TECHNICAL SERVICE BULLETIN

Coverplate Bolts G20 Series Transfer Pumps

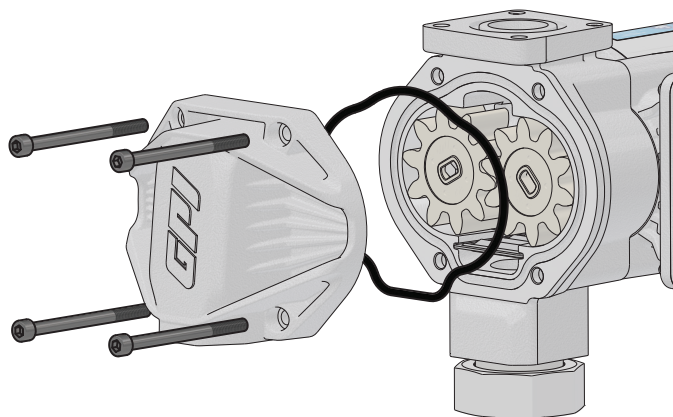
Due to a supplier quality issue, GPI received a limited number of fasteners that did not meet strength specifications. These fasteners have the potential to break under normal operating conditions.

GPI recommends replacement of the four cover-plate bolts on all pumps manufactured within the specified date range.

1. Remove the four coverplate bolts. After removal of coverplate it may be necessary to use locking pliers to grip and unthread broken bolts. Use caution to prevent any damage to the machined surface of the pump housing.
2. Examine the o-ring and replace if necessary.
3. Reinstall the coverplate. Using an "X" pattern, torque bolts to 95-105 in-lbs.

4X M6-1.0 x 80mm
Torque to
95 to 105 in-lbs

Replace if needed
